UNITED STATES PATENT AND TRADEMARK OFFICE

APPLICATION NO.	FILING DATE	FIRST NAMED INVENTOR	ATTORNEY DOCKET NO.	CONFIRMATION NO.
10/562,453	01/13/2006	Toshio Takeshita	282057US6PCT	3508
22850	7590	09/18/2009		
OBLON, SPIVAK, MCCLELLAND MAIER & NEUSTADT, L.L.P. 1940 DUKE STREET ALEXANDRIA, VA 22314				
EXAMINER				
KWON, ASHLEY M				
ART UNIT		PAPER NUMBER		
1795				
NOTIFICATION DATE		DELIVERY MODE		
09/18/2009		ELECTRONIC

Office Action Summary

DETAILED ACTION

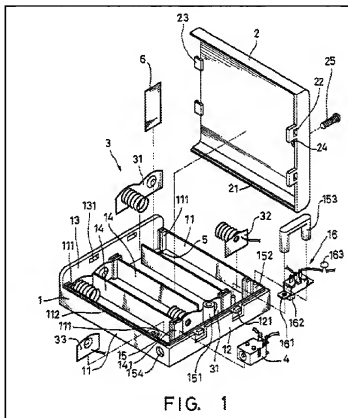
Regarding claim 4, both Mitsui in view of Victor and Ebine teach the battery apparatus as claimed in claim 1, wherein: said case includes a main body portion (*Mitsui*: upper casing half, 34, and mid casing half, 35; see fig. 1; *Victor*: see fig. 1) extending in the length direction with a uniform size in said width direction, and a bottom portion (*Mitsui*: terminal mounting plate, 36; see fig. 1; *Victor*: bottom portion, 12a; see fig. 1) provided at one of thickness directions at a central portion in the width direction of said main body portion and extending in said length direction with a smaller width size than the width of said bottom portion, said bottom surface is formed with a surface of said bottom portion, said plurality of engaging pieces are formed by projecting from said bottom surface portion at both sides in said width direction (*Mitsui*: see fig. 5; *Victor*: see fig. 1), a plurality of concave portions extending in said length direction are formed by said respective engaging pieces (*Mitsui*: see fig. 5; *Victor*: recess, 12c; see fig. 1);

Regarding claim 14, Mitsui in view of Victor and Ebine teaches the batter apparatus as cited in claim 1, wherein the battery-side terminal is provided at an end portion in the length direction of a bottom portion, and the convex portion extends in the width direction above the battery-side terminal. As explained above for claim 1, if the engagement boss and (73) and hole (52) were reversed the battery-side terminal is provided at an end portion in the length direction of a bottom portion, and the convex portion extends in the width direction above the battery-side terminal (see figs. 5 and 7).

FIG.5

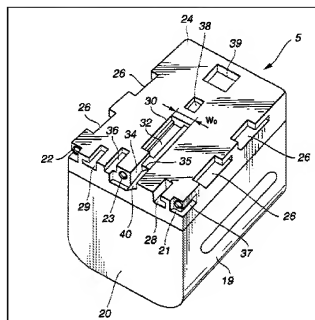
However, Takeshita teaches a battery apparatus comprising an identification portion including a recess (discrimination recess, 30; see fig. 5) having a size based on an electrical characteristic of the battery, the recess configured to receive a projection (discriminating projection, 73; see fig. 6) of the battery mounting section having a size based on a desired electrical characteristic for the electronic device, in order to determine whether or not the battery loading device is an appropriate battery loading device for the battery pack (see col. 5, lines 55-58). It would have been obvious to a person of ordinary skill in the art that the electrical characteristics one would consider when determining if the battery pack is appropriate for the specific battery loading device would include capacity and suitable charging current value. The combination of familiar elements is likely to be obvious when it does no more than yield predictable results. See *KSR International Co. v. Teleflex Inc.*, 550 U.S. ___, ___, 82 USPQ2d 1385, 1395 – 97 (2007) (see MPEP § 2143, A.). Therefore, it would have been obvious for a person of ordinary skill in the art to combine the identification portion taught by Takeshita with the batter apparatus taught by Mitsui in order to prevent unsuitable battery packs from being loaded onto specific battery loading devices.

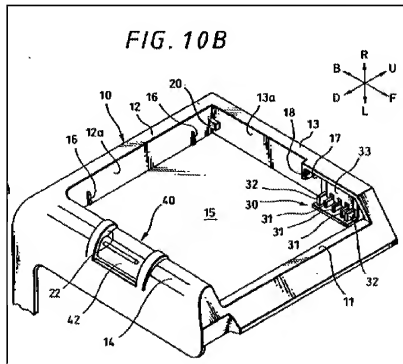
However, Ebine teaches a battery terminal structure (battery side terminal, 120) having a convex portion (terminal pressing rib, 116) projecting in the length direction from an end surface of the case and extending in the width direction along the end surface of the case, the convex portion disposed at a distance in the thickness direction from the battery-side terminal, and the convex portion being located on a same end surface of the case as the battery-side terminal and extends in the width direction of the case a distance greater than a distance that the electrodes of the battery-side terminal extend in the width direction of case (see fig. 5). As explained above, this limitation is

met as long as the convex portion is extends in a width direction greater than the battery terminal extends. It is clear from Fig 5 that the terminal pressing rib (116) extends in a width direction greater than the battery terminal because it comes into contact with terminal positioning ribs (109) that extend along length direction on either side of the battery terminal. The simple substitution of one known element for another is likely to be obvious when predictable results are achieved. See *KSR International Co. v. Teleflex Inc.*, 550 U.S. ___, 82 USPQ2d 1385, 1395 – 97 (2007) (see MPEP § 2143, B.). Therefore, since Ebine teaches a known configuration for a battery-side terminal, it would have been obvious to a person of ordinary skill in the art to substitute the terminals taught by Mitsui with the terminal comprising convex portions taught by Ebine in order to increase positional accuracy and dimensional accuracy of both the terminals themselves and engagement of the terminal (see paragraph 9).
